Conceptual Review Agenda

Schedule for 01/28/13 to 01/28/13

Monday, January 28, 2013

429 S Whitcomb St Carriage House & Home Addition

SECOND FLOOR PLAN
SCALE: 1/4"=1'-0"

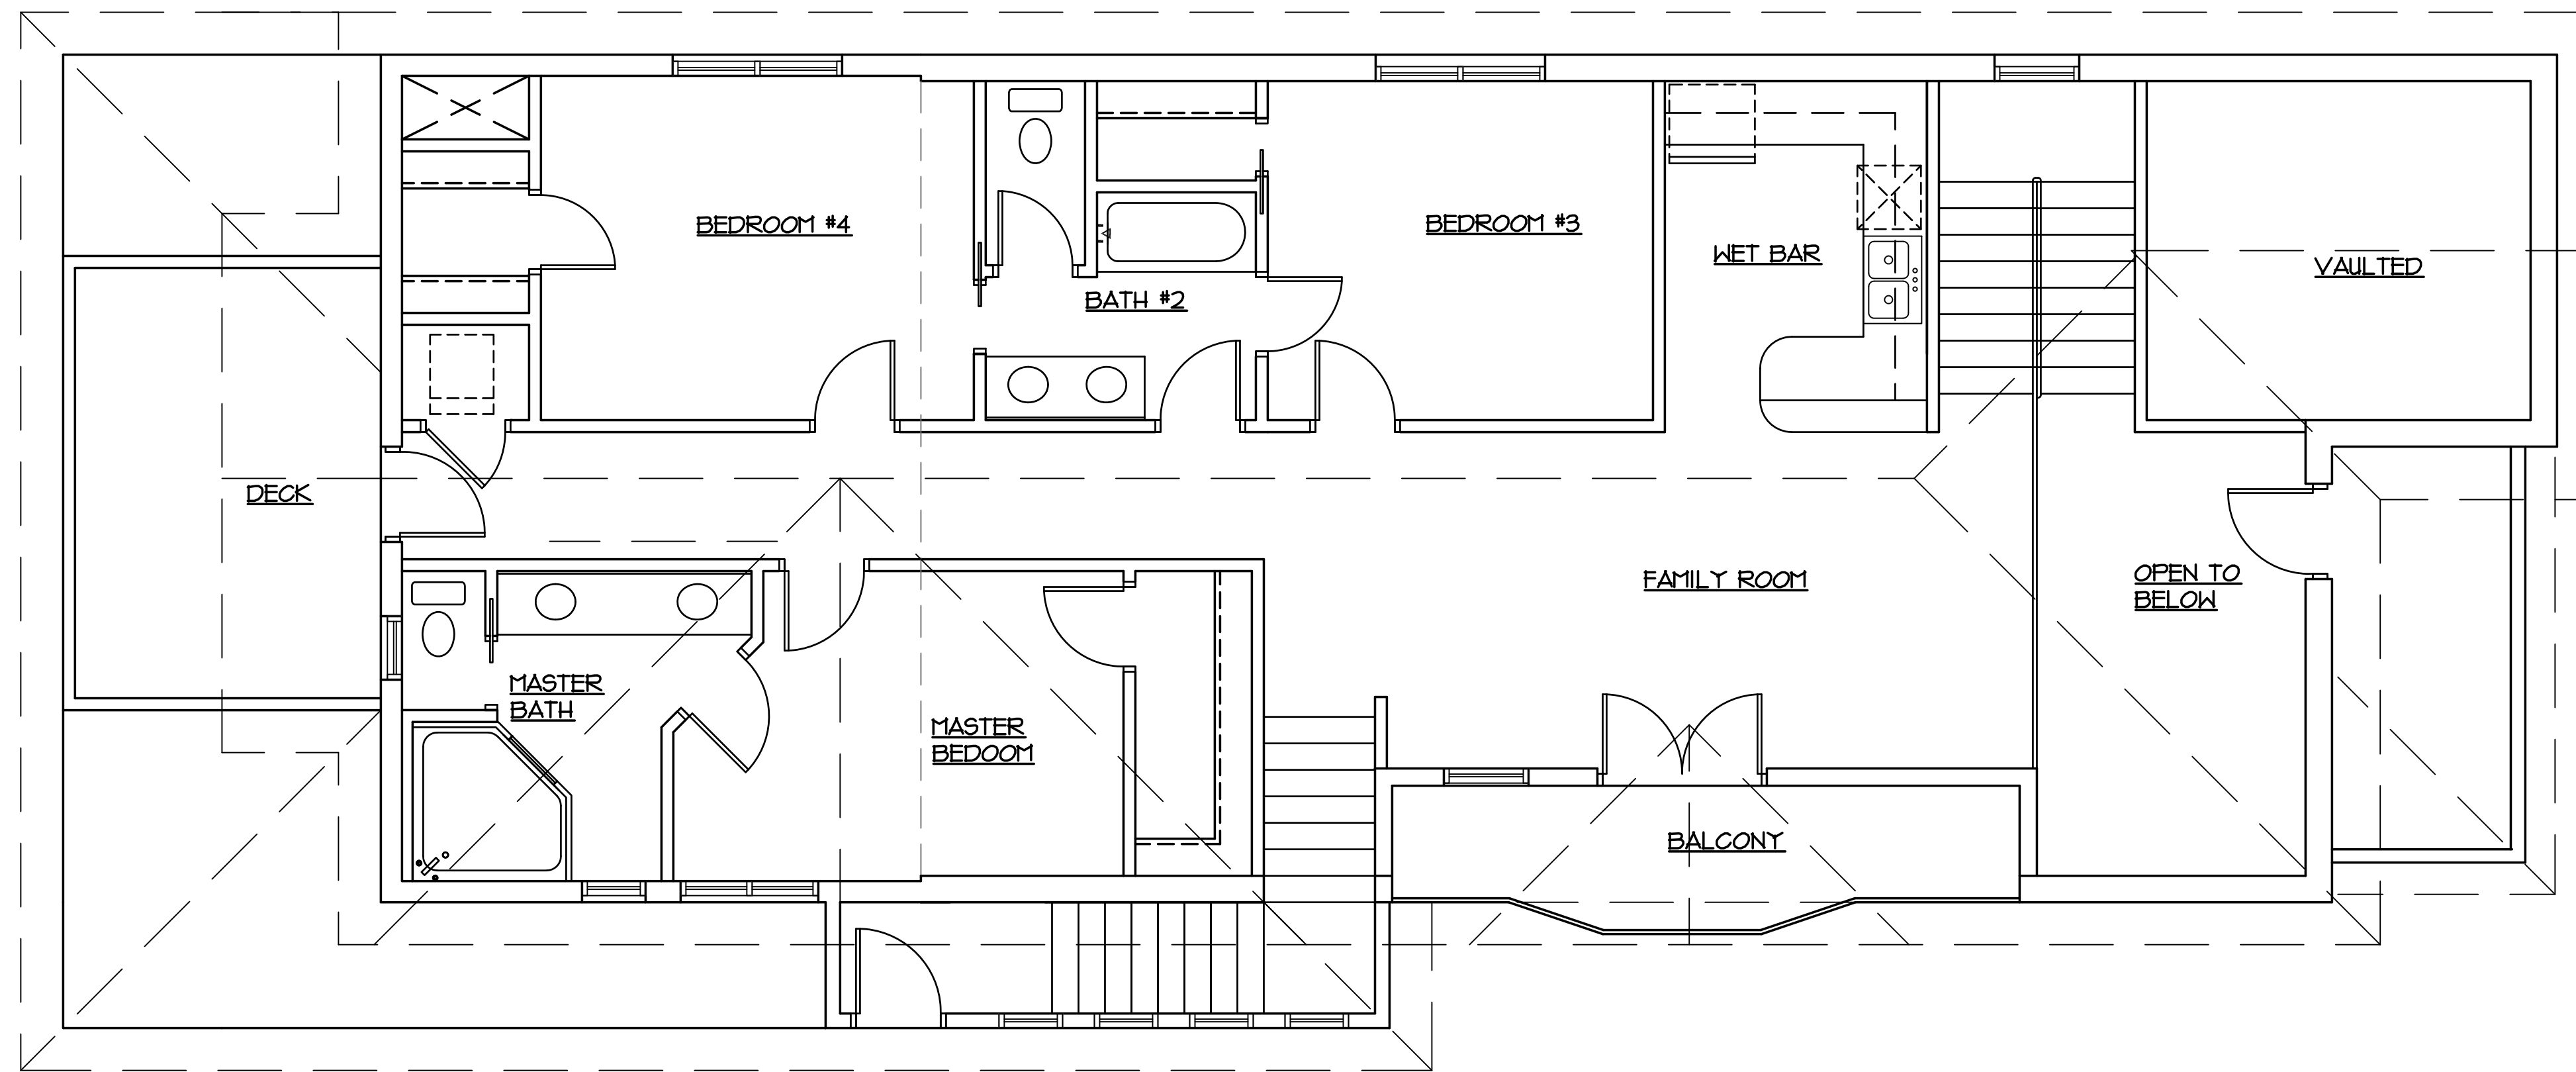
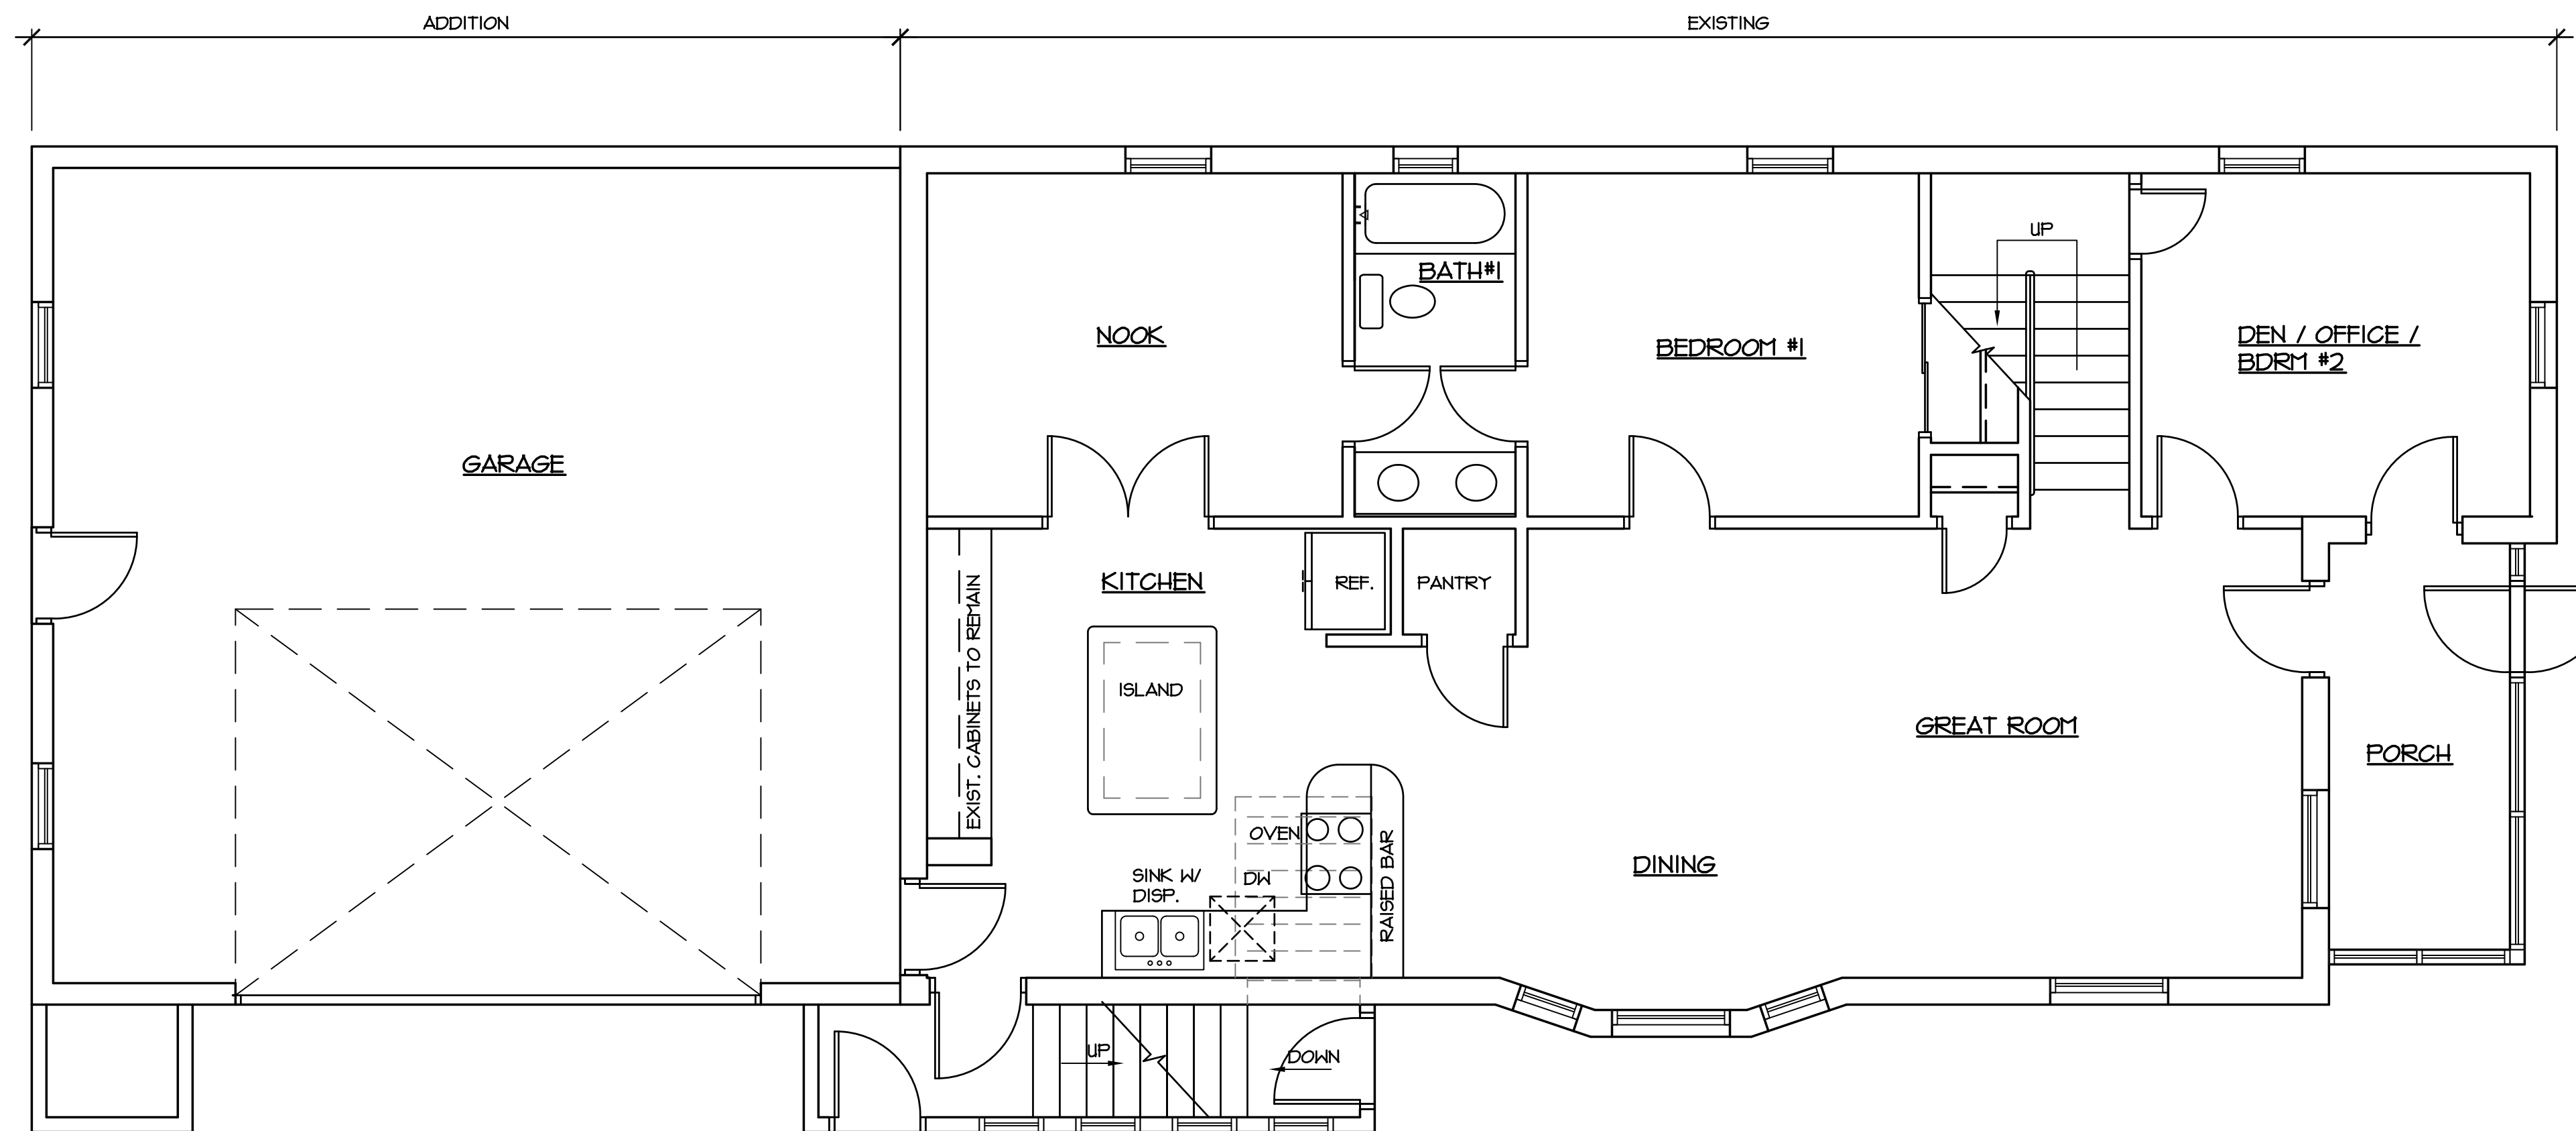
2. There are two different second level floor plans submitted with the conceptual review application. Which one is correct? Both show a wet bar area on the 2nd floor. Please note that no cooking appliance is allowed on the 2nd floor.

MVG MORNINGSTAR
FT. COLINS, CO.

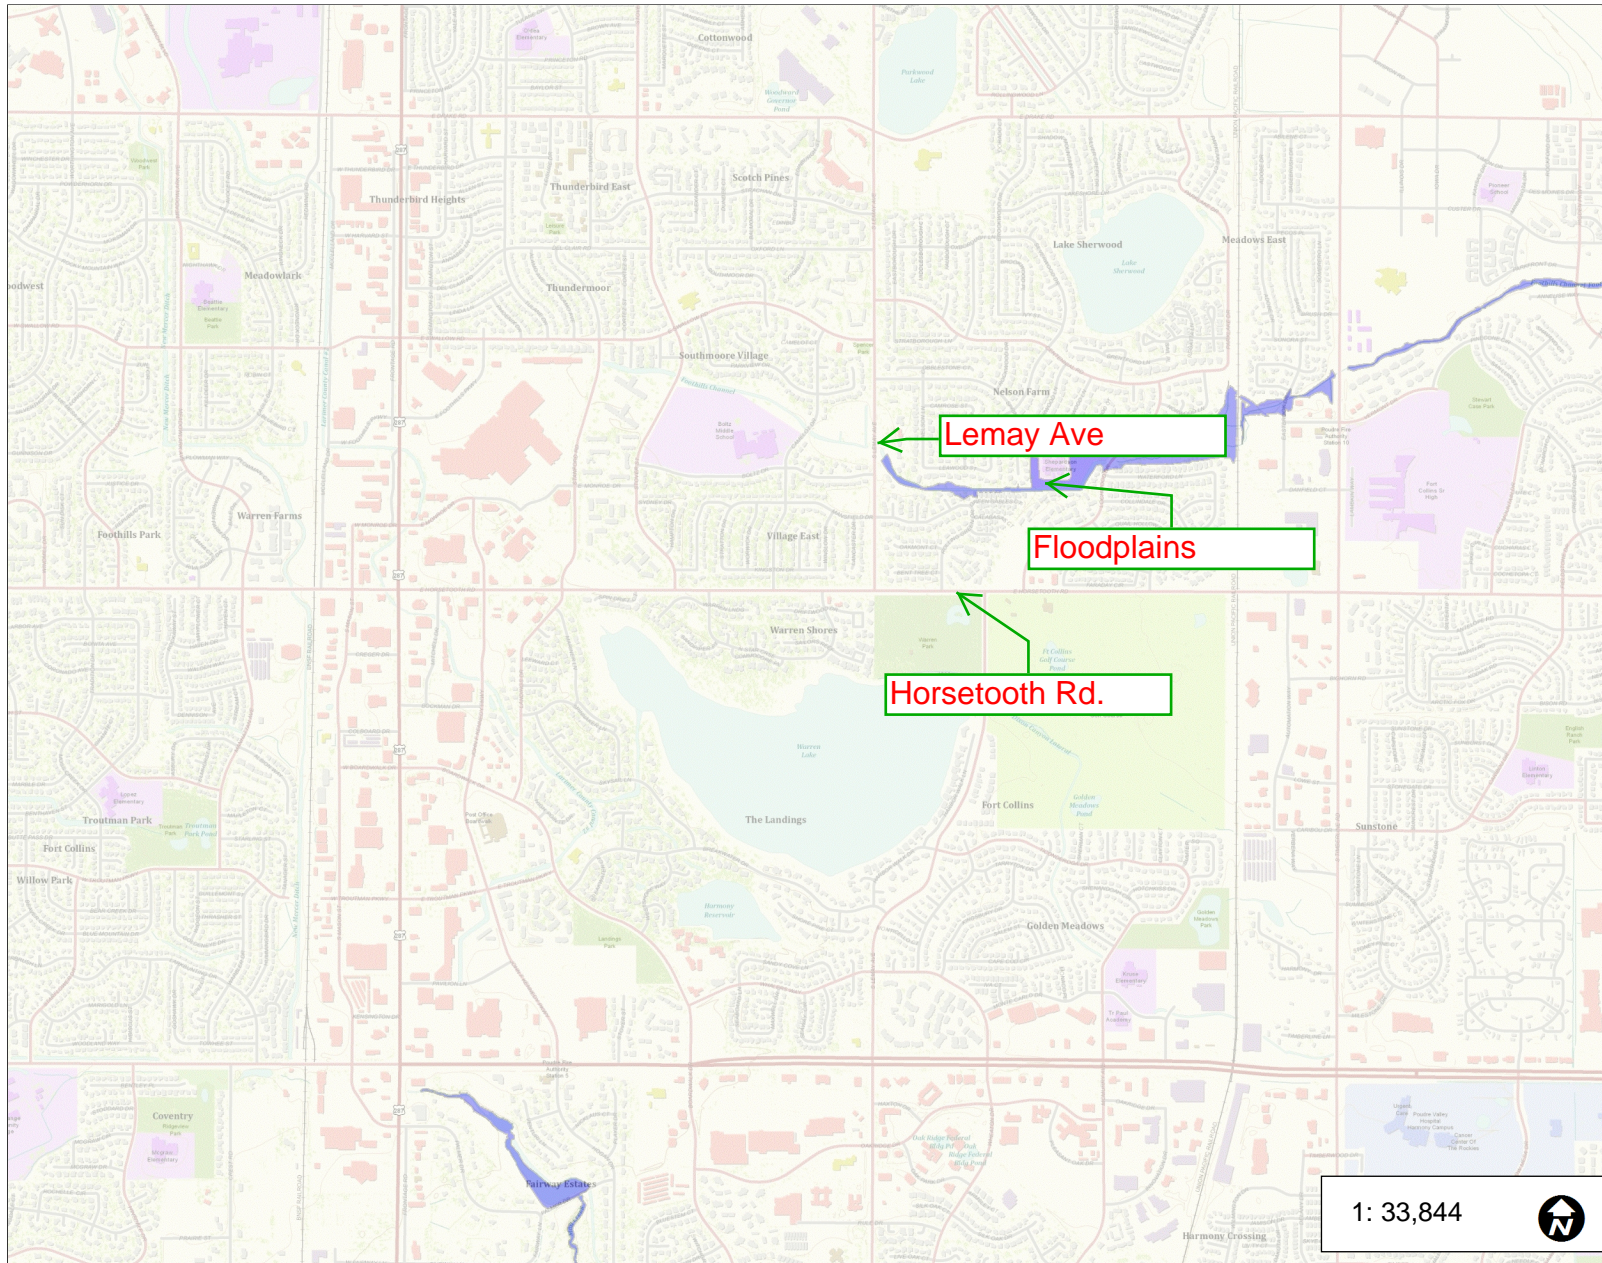
The site plan provide with the conceptual review packet provides for acceptable fire access. The revised site plan creates an "out of access" situation on the north side of the facility. This condition shall require further evaluation and discussion.
